# 18-033MPR – PENZONE PATIO

Review and approval of Minor Project Review for a patio and associated site improvements.

Proposal for a 430-square-foot patio and associated site improvements for an existing building located in the Sawmill Center Neighborhood within the Bridge Street District.

### 4. Site Plan

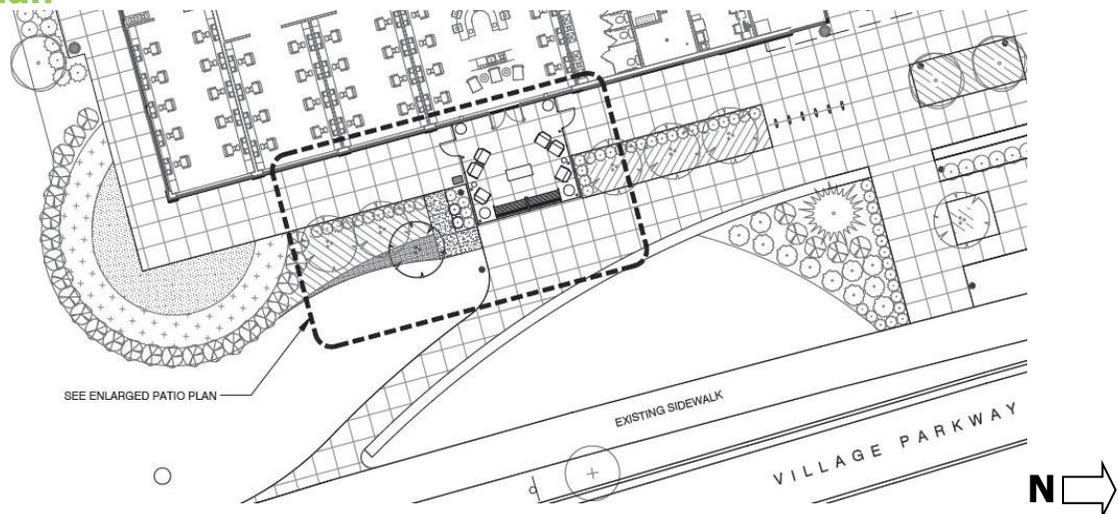
The location of the patio enclosure, in the context of the site, limits pedestrian access around the full extent of the building. To address the ART's concerns and meet the BSD Code – Walkability Standards, the applicant has amended their design to provide a four-foot wide sidewalk extension around the enclosed patio. The path must meet the ADA requirements of an egress slope not to exceed five percent, and a slope across not exceed two percent. The proposal alters the landscape plan to ensure the existing plants are relocated, and all accent lighting is maintained. As proposed, interior modifications are required to eliminate the east exit as a viable exit in the event of a fire.

- c) **Internal circulation system and driveways provide safe and efficient access for all.**  
Criteria Met with Condition. No alterations within the right-of-way are proposed. Bicycle, and vehicular circulation is not impacted with this proposal. Pedestrian circulation is impacted by the proposal; however, maintains full circulation around the building. The applicant is required to provide verification the path meets the slope requirements for accessibility in accordance with the Americans with Disabilities Act.

- f) **The scale and design of the proposed development allows for the adequate provision of services.**  
Criteria Met with Condition. The proposed site alternations do not impede the ability to provide adequate provision of public services. The applicant should work with the Washington Township Fire Department to ensure the safe location and operation of the fire pit.

- 1) That the applicant coordinate with the Washington Township Fire Department to ensure safe siting and operation of the fire pit; and,
- 2) That the applicant provide verification at Building Permitting the pedestrian paths slope is in compliance with the Americans with Disabilities Act.
